Re: Harold D. Thompson Regional Water Reclamation Facility (HDTRWRF)
Lower Fountain Metropolitan Sewage Disposal District (LFMSDD)

Submittal No.:	13121-003
Date of Submittal:	April 18, 2012
Submittal No.:	13121-003 – Supplemental Information
Date of Submittal:	May 15, 2012
Title:	Pumping & Disinfection Building: Metal Building; Roof System; Textureclad Wall Panels; Liner Panels
Specification Section:	13121 – Prefabricated Metal Building
Manufacturers:	Lefever Building Systems; VP Buildings/Varco Pruden

SUBJECT: REVISED ENDWALL @ 1

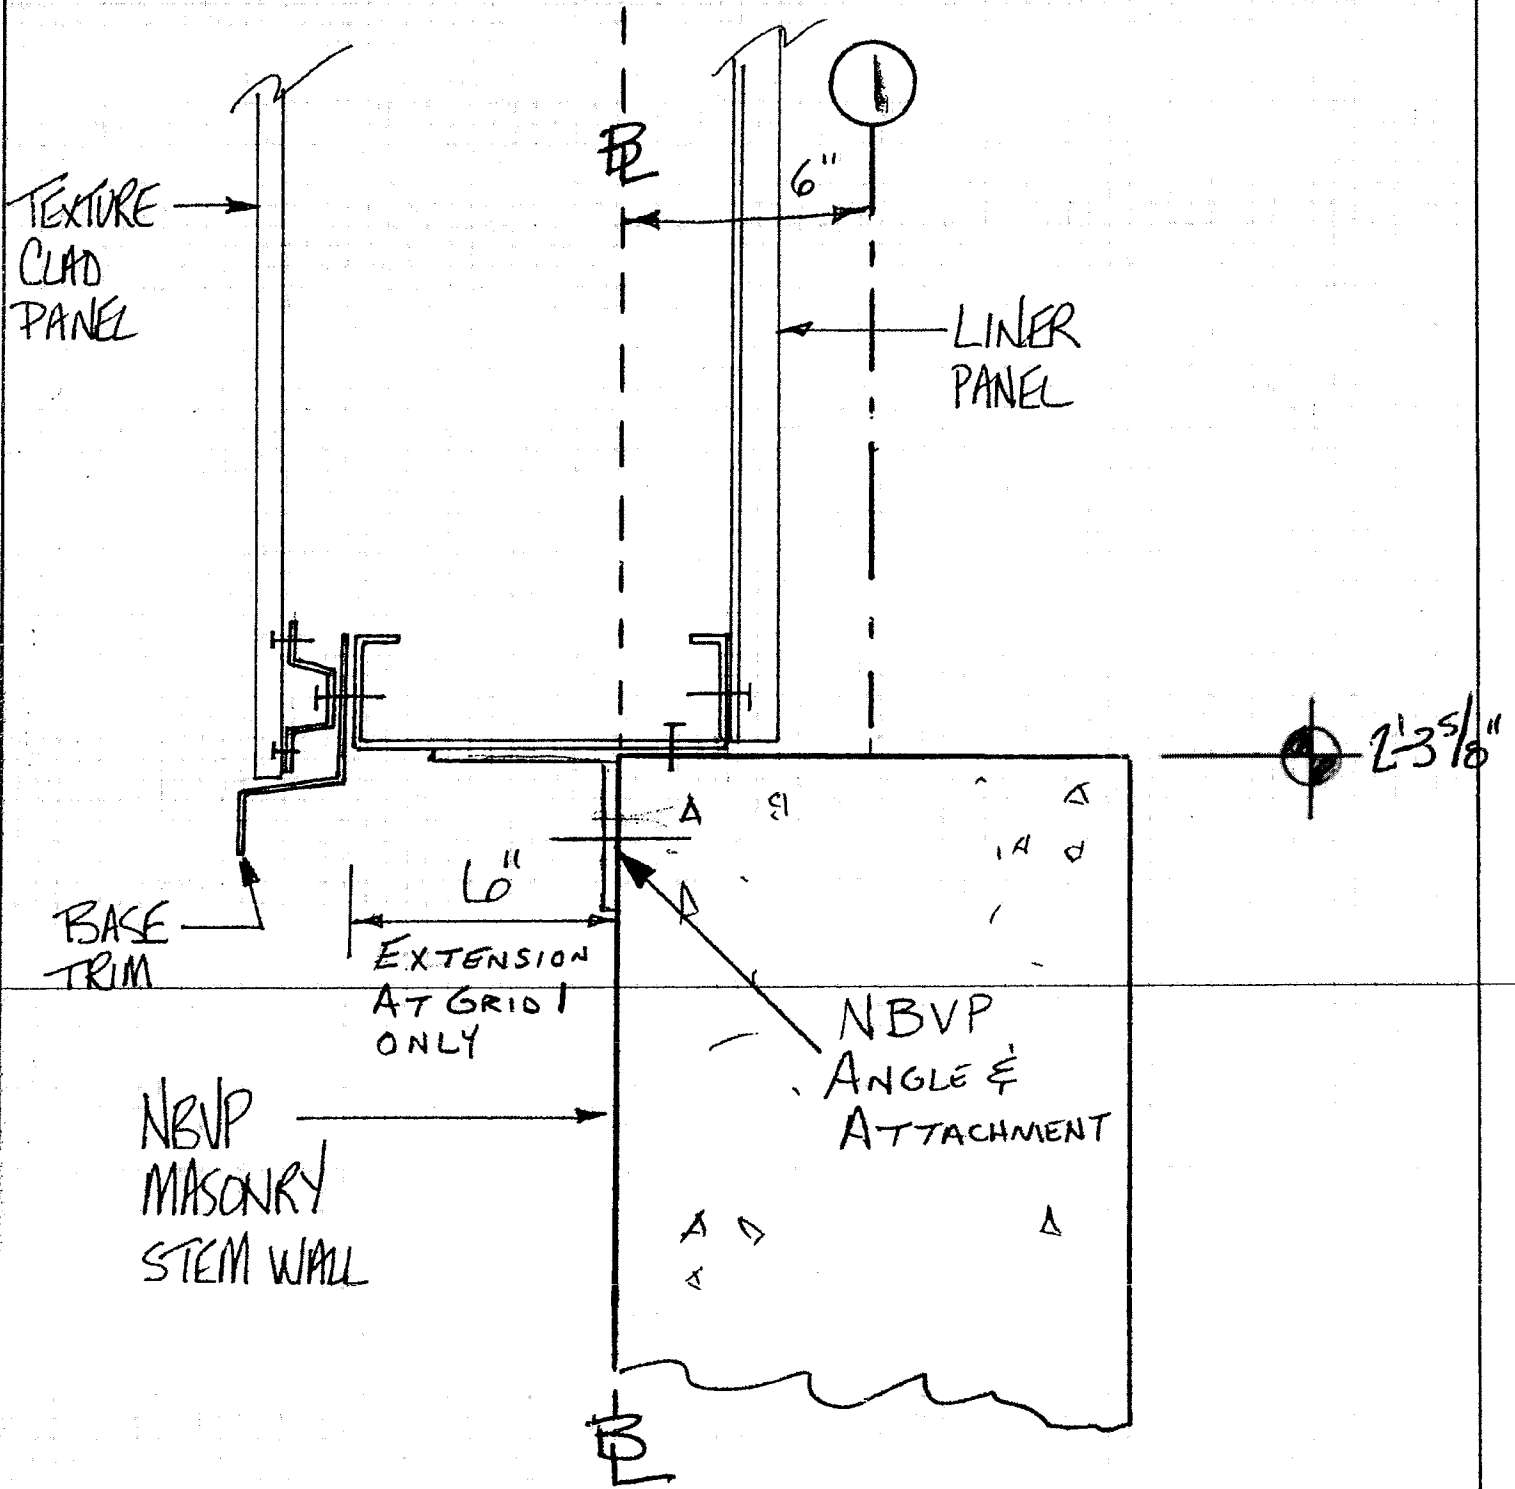
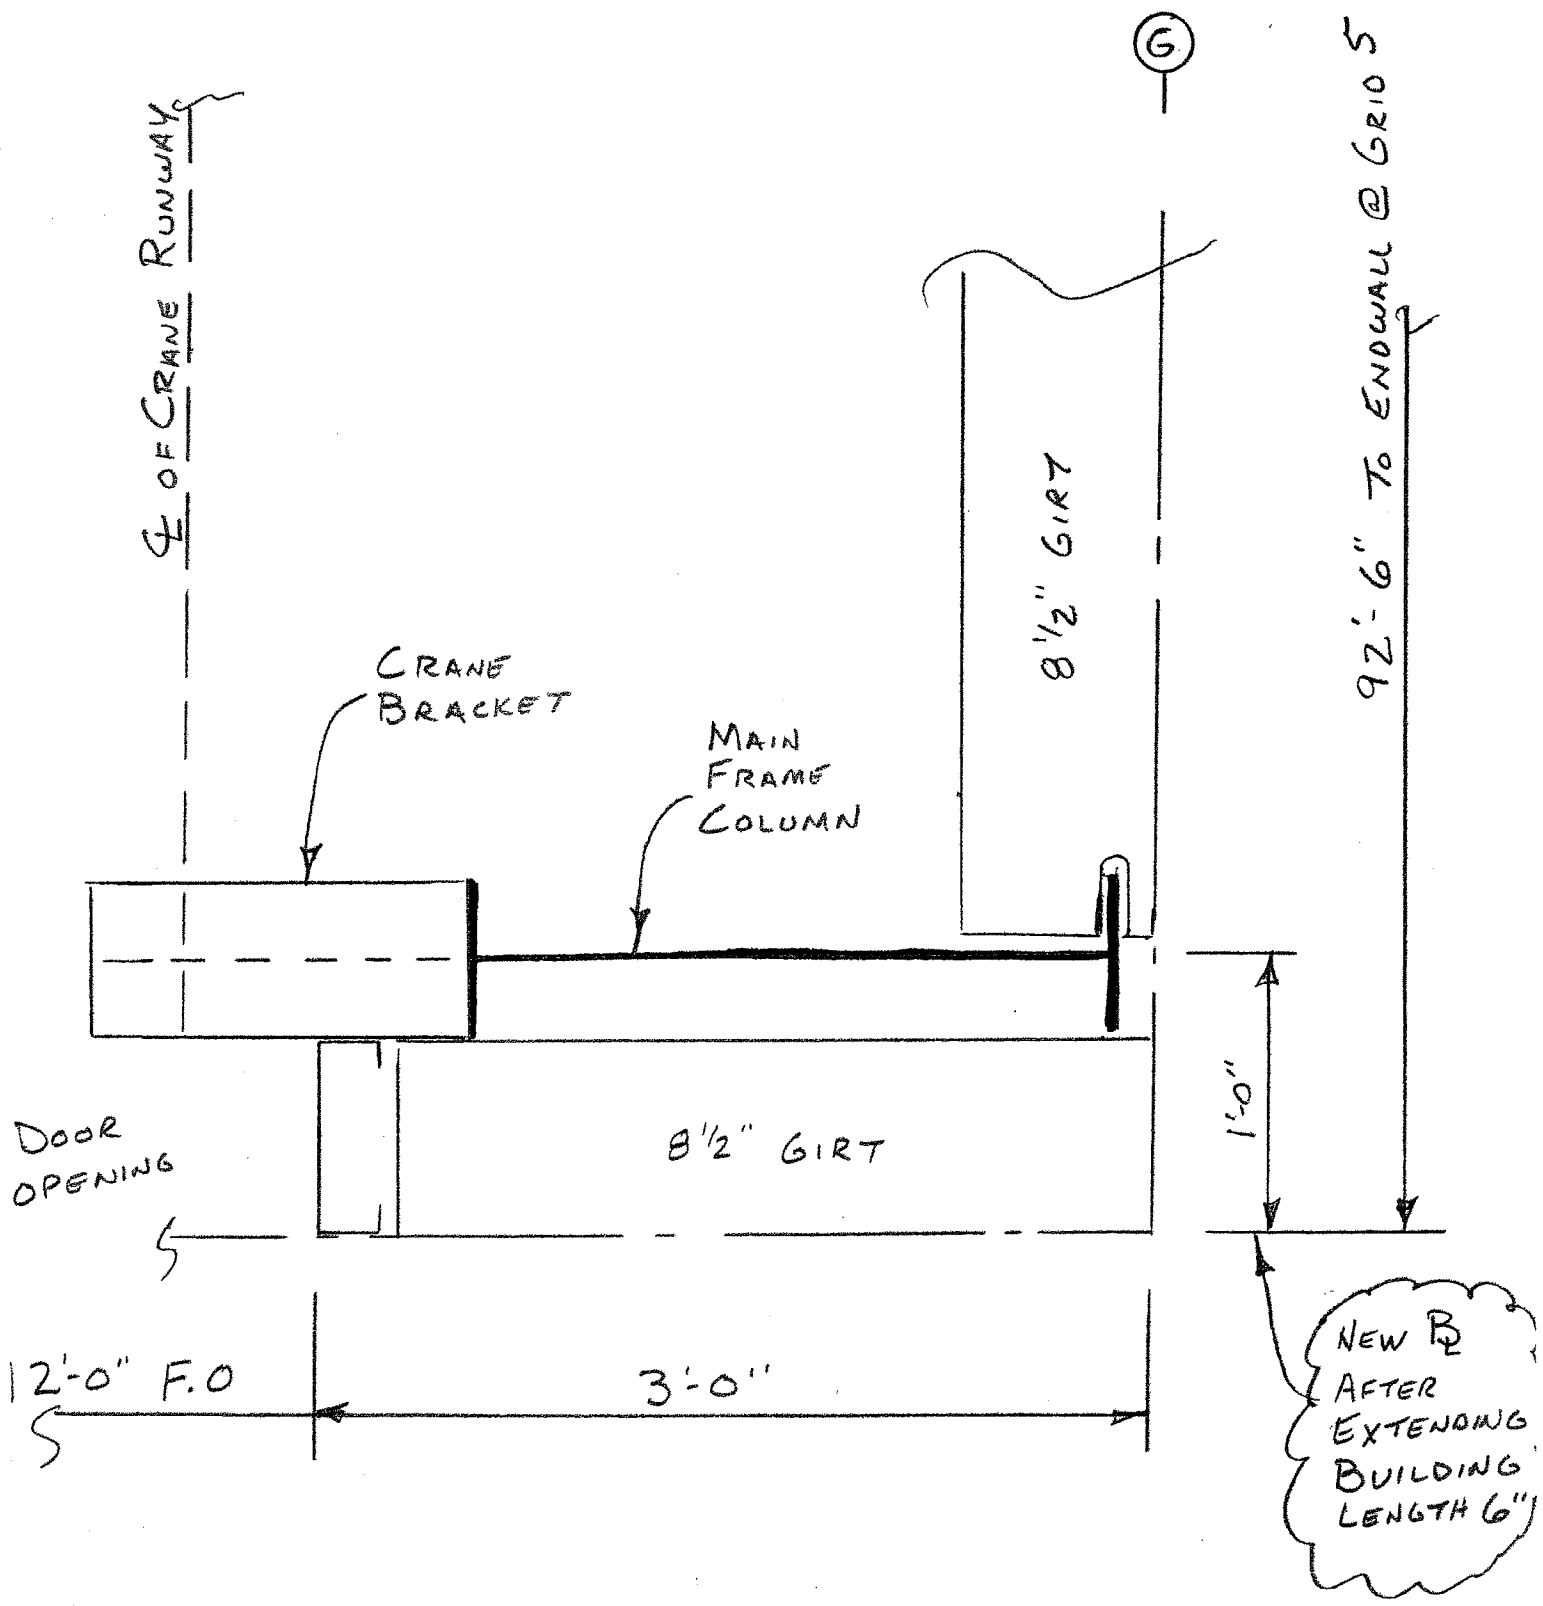
- 1) A note on the drawing identifies the clearance issue with the overhead door utilizing an inset girt. Based upon supplemental information provided through WCMI titled, *"REVISED END WALL @ 1"* (grid line 1), a 6" extension to grid line 1 will be installed. We take no exception to VP Buildings' modification to the west endwall utilizing an outset girt. A copy of the detail numbered 12-6490 HD Tompson has been attached as a reference.

SHAW-BOX[®] WORLD SERIES[™] MONORAIL HOISTS

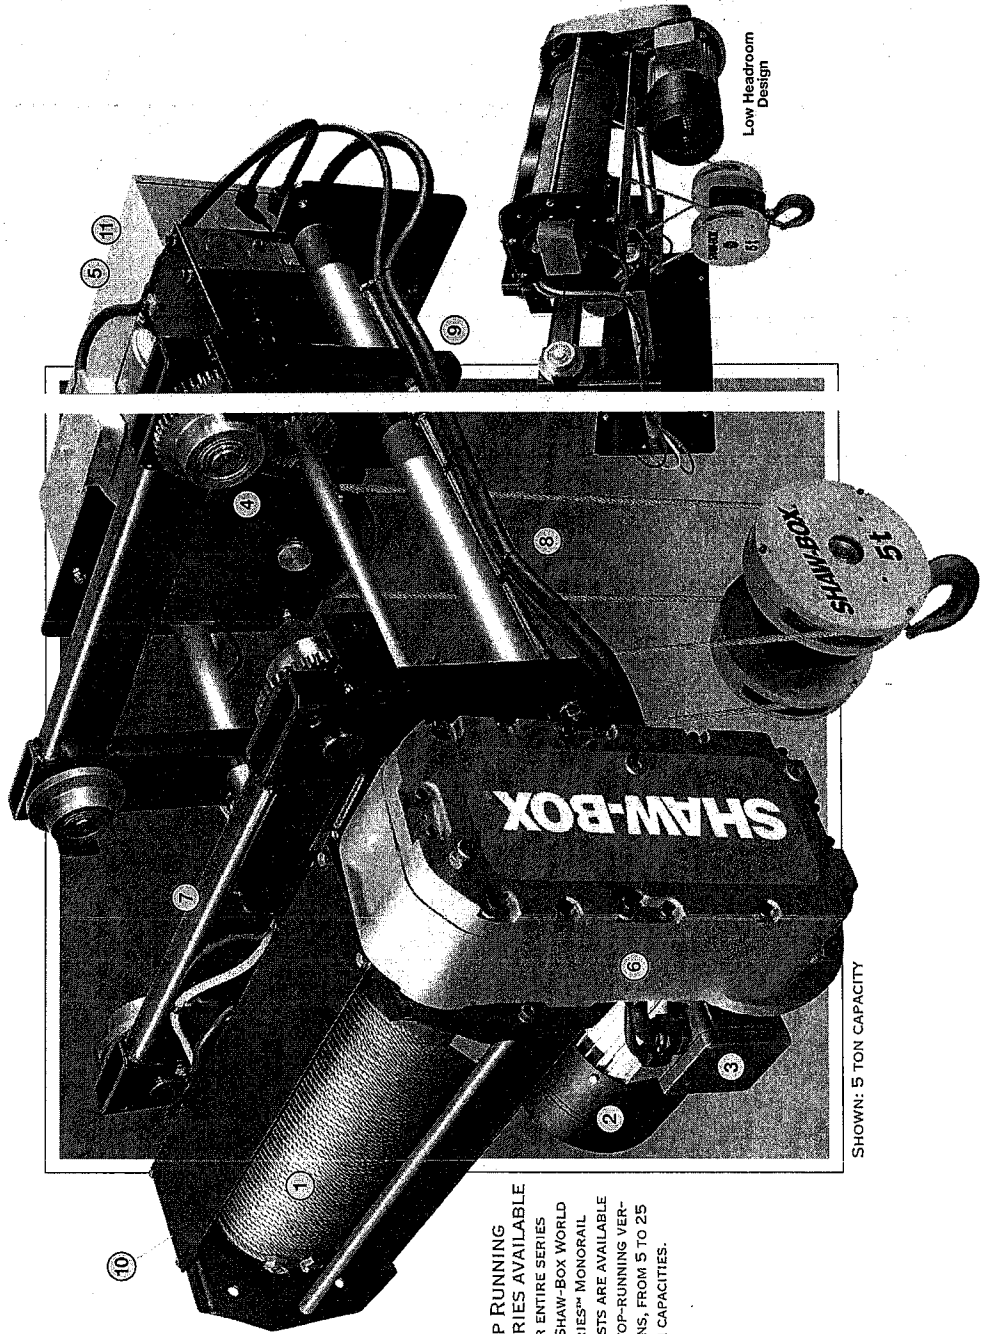
1. Shaw-Box World Series Monorail Wire Rope Hoists: **No Exception Taken** and **Revise and Resubmit**
 - a. We take no exception to the span of 48' as it sits inside of the overall 55' outside dimension of the building.

- b. We take no exception to the 2-ton lift capacity.
 - c. The submittal indicates the crane has an available lift of 40'-0"; however, the general specifications indicate the actual lift is referenced to the drawing provided. In accordance with Construction Drawing PD-2A, the minimum dimension from finish floor of the pump room to the crane hook must be a minimum of 30'-4". Based on the information provided, it would appear the available lift is 40'-0". Please submit confirmation the 40'-0" lift is available on the crane to be provided.
